**LEVY NUCLEAR PLANT, UNITS 1 AND 2  
DOCKET NOS. 52-029 AND 52-030  
SUPPLEMENT 6 TO RESPONSE TO REQUEST FOR ADDITIONAL INFORMATION LETTER  
NO. 085 RELATED TO SEISMIC SYSTEM ANALYSIS**

**Levy Nuclear Plant Units 1 and 2  
Supplement 6 to Response to NRC Request for Additional Information Letter No. 085  
Related to SRP Section 3.7.2 for the Combined License Application,  
Dated March 16, 2010**

**NRC RAI NUMBER:** 03.07.02-2

**PGN RAI ID #: L-0954**

FIGURE RAI 03.07.02-02-1 Rev 1

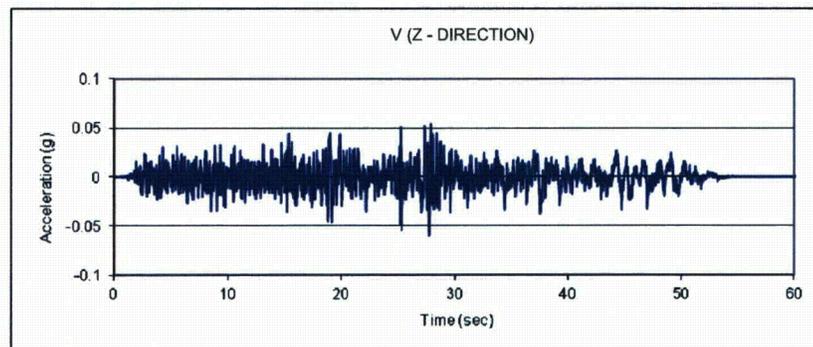
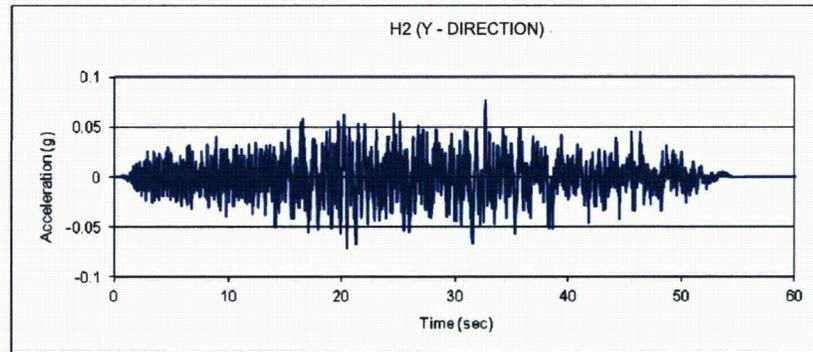
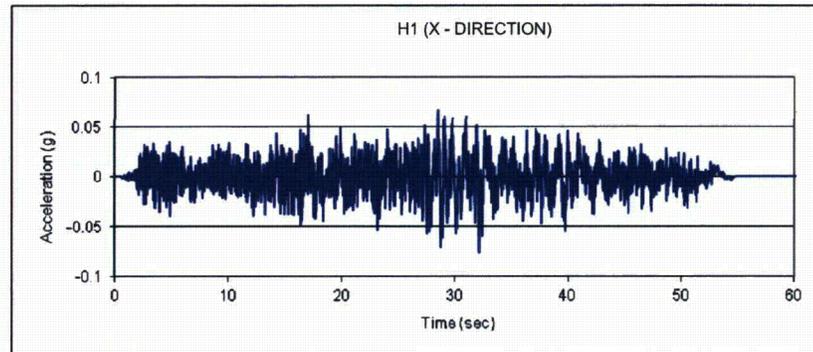
Figures RAI 03.07.02-02-1 through RAI 03.07.02-02-16 have been revised to show the corrected input time histories and the revised Floor Response Spectra (FRS) at the six AP1000 key nodes. The revised FRS are essentially the same as those submitted via Letter NPD-NRC-2011-047. The only exception is the X-direction upper bound soil profile FRS at node 2078, where the revised spectrum is lower than the original FRS in the 30 Hz. frequency range. This reduction is attributed to "slight adjustment of a

- 2) Revise Figures RAI 03.07.02-02-1 through RAI 03.07.02-02-16. These revised figures are included in Attachment 03.07.02-02 S A.

FIGURE RAI 03.07.02-02-4 Rev 1

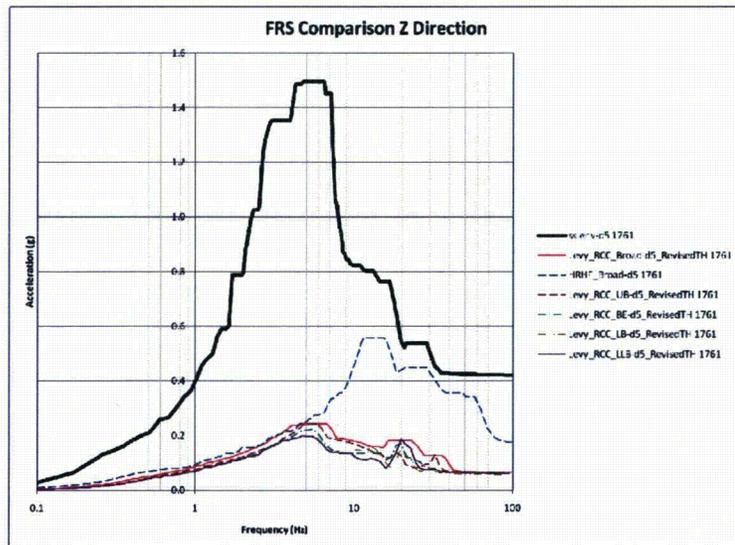
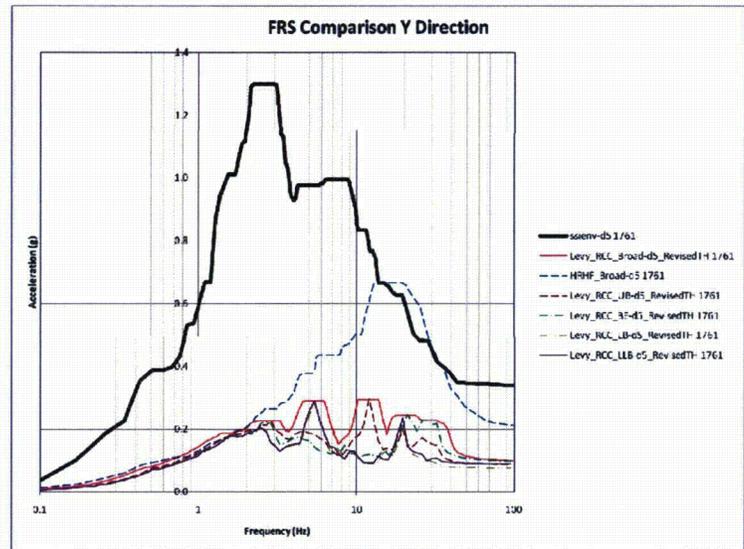
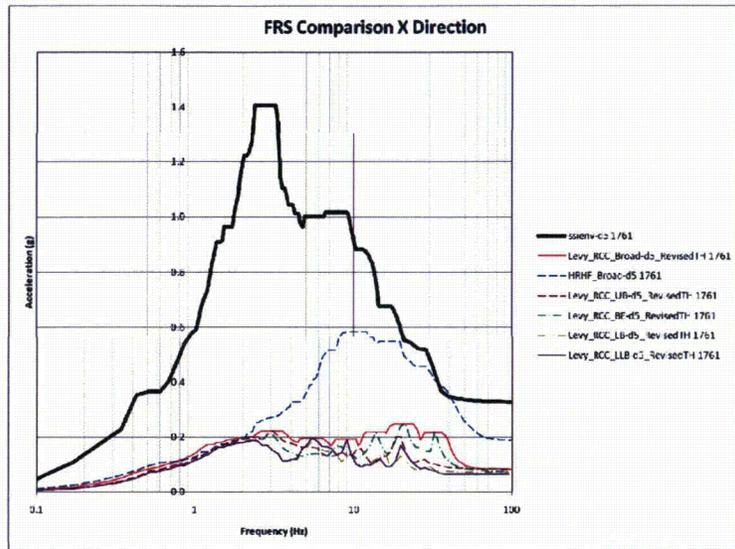
frequency no. in SASSI to optimize the un-interpolated/interpolated transfer function". The revised LNP FRS are enveloped by the generic AP1000 FRS at the six key nodes.
